Administrative Staff Report

Project Name: Stepper - Critical Area Buffer Reduction (CABR)

Type of Application: CABR Type II

Permit Number: 22-04798

6. Site Design

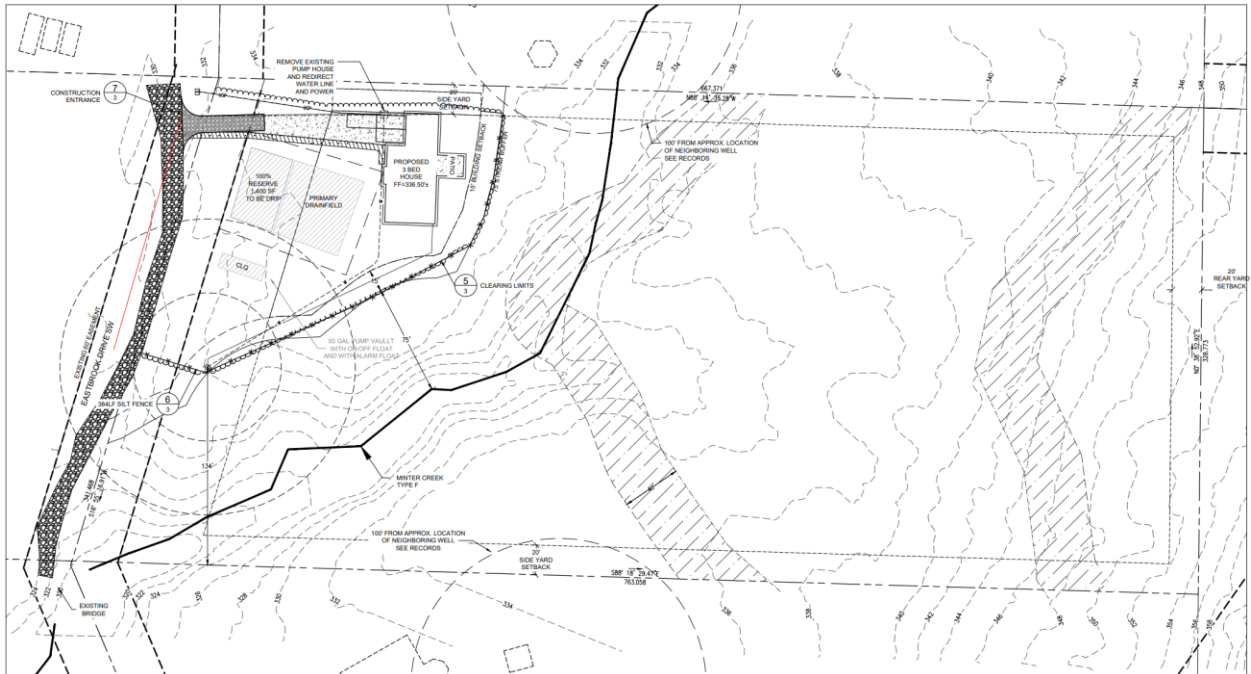
The image below shows the proposed footprint of the home, the existing driveway, associated parking, onsite septic (OSS), including drainfields and drinking well. The site plan also shows the location of the onsite wetland, stream and those buffers.
